**PCN#20160602000B
BGA Tray Change
Final Change Notification**

PCN Number:	20160602000B		PCN Date:	April 06. 2017
Title:	BGA Tray Change			
Customer Contact:	PCN Manager		Dept:	Quality Services
Change Type:				
<input type="checkbox"/> Assembly Site	<input type="checkbox"/> Assembly Process	<input type="checkbox"/> Assembly Materials		
<input type="checkbox"/> Design	<input type="checkbox"/> Electrical Specification	<input type="checkbox"/> Mechanical Specification		
<input type="checkbox"/> Test Site	<input checked="" type="checkbox"/> Packing/Shipping/Labeling	<input type="checkbox"/> Test Process		
<input type="checkbox"/> Wafer Bump Site	<input type="checkbox"/> Wafer Bump Material	<input type="checkbox"/> Wafer Bump Process		
<input type="checkbox"/> Wafer Fab Site	<input type="checkbox"/> Wafer Fab Materials	<input type="checkbox"/> Wafer Fab Process		
<input type="checkbox"/> Part number change

Group 1 Device: 9x9mm BGA Tray

Group 2 Device: 10x10mm BGA Tray

TRAY DESIGN CONSIDERATION and COMPARISON

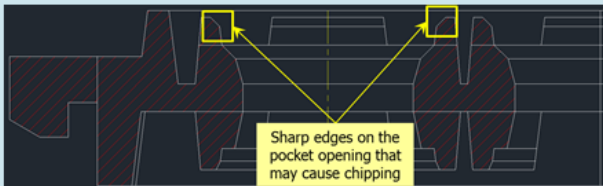
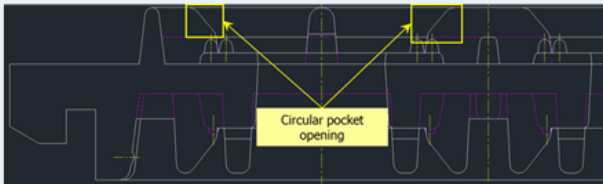
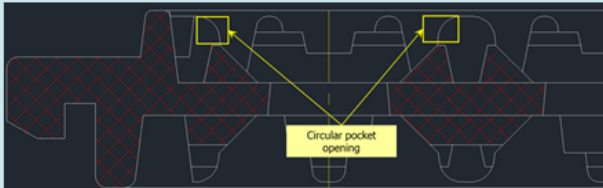
TRAY	POCKET OPENING
4209920-0001 (Kostat)- CURRENT	 Sharp edges on the pocket opening that may cause chipping
4204956-0001 (Ohkawa)- CURRENT	 Circular pocket opening
4222683-0001 (PEAK)- PROPOSED	 Circular pocket opening

TRAY	FENCE DESIGN	
	TOP	BOTTOM
4209920-0001 (Kostat)- CURRENT		
4204956-0001 (Ohkawa)- CURRENT		
4222683-0001 (PEAK)- PROPOSED

Dimensional Comparison:

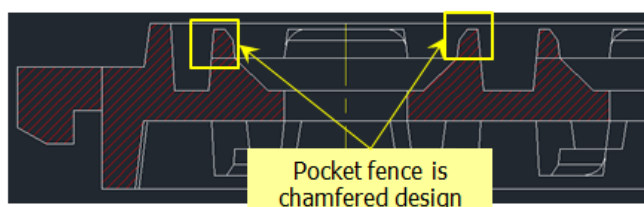
Items Description	4209920-0001 (Kostat)			4204956-0001 (Ohkawa)			4222683-0001 (PEAK)			REMARKS
	DIM	Upper Limits	Lower Limits	DIM	Upper Limits	Lower Limits	DIM	Upper Limits	Lower Limits	
Overall Length	322.6	322.85	322.35	322.6	322.85	322.35	322.6	322.85	322.35	SAME
Layout Length	315.0	315.25	314.75	315.0	315.25	314.75	315.0	315.25	314.75	SAME
Layout Width	135.9	136.15	135.65	135.9	136.15	135.65	135.9	136.15	135.65	SAME
Layout Length on Top Stack frame	311.15	311.40	311.02	311.15	311.40	311.02	311.15	311.40	311.02	SAME
Layout Width on Top Stack frame	132.05	132.30	131.92	132.05	132.30	131.92	132.08	132.33	131.95	SAME
Layout Length on Bottom Stack frame	311.66	311.91	311.53	311.66	311.91	311.53	311.66	311.91	311.53	SAME
Layout Width on Bottom Stack frame	132.56	132.81	132.43	132.56	132.81	132.43	132.59	132.84	132.46	SAME
End Tab Length	92.10	92.35	91.85	92.10	92.35	91.85	92.1	92.35	91.85	SAME
Overall Height	7.62	7.75	7.49	7.62	7.75	7.49	7.62	7.75	7.49	SAME

Stack Height	1.27	1.40	1.14	1.27	1.40	1.14	1.27	1.40	1.14	SAME
Tray Matrix No.	10x26			8x21			10x26			CHANGE
Pitch M	10.35	10.48	10.22	10.55	10.68	10.42	10.35	10.48	10.22	CHANGE
Pitch M3	12.80	12.93	12.67	7.45	7.58	7.32	12.80	12.93	12.67	CHANGE
Pitch M1	10.00	10.13	9.87	10.00	10.13	9.87	10.00	10.13	9.87	CHANGE
Pitch M2	11.80	11.93	11.67	14.75	14.88	14.62	11.80	11.93	11.67	CHANGE
Cavity opening	12.75	12.88	12.62	11.03	11.16	10.90	14.18	14.31	14.05	CHANGE
Pedestal Design	SLOPE			PEDESTAL			SLOPE			CHANGE
Package seating height (Top)	1.50	1.63	1.37	1.40	1.48	1.32	1.50	1.60	1.40	CHANGE
Package seating height (Bottom)	1.62	1.75	1.49	1.70	1.78	1.62	1.50	1.60	1.40	CHANGE

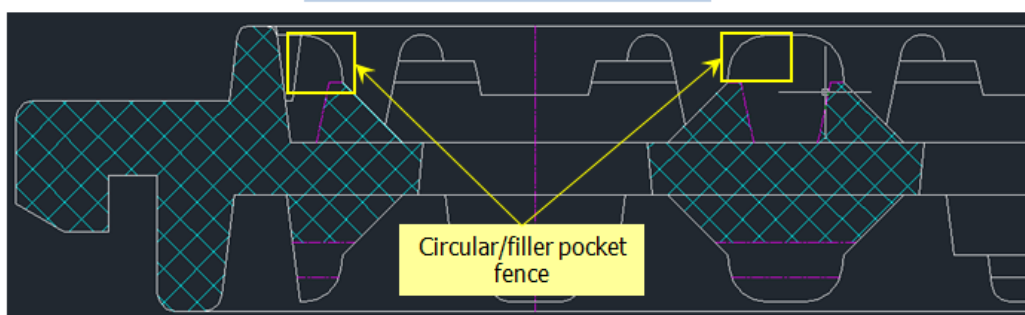
What	From	To
Stock #/Supplier	4211727-0001/KOSTAT	4222660-0001/PEAK
Matrix (Column x Rows)	8x21	8x23
Surface Resistivity, Ohms/Sq.	10^5 to 10^9	10^5 to 10^9
Raw Material	PES	MPPO
Tray Color	Black	Black
Temperature Rating	150 °C	150 °C
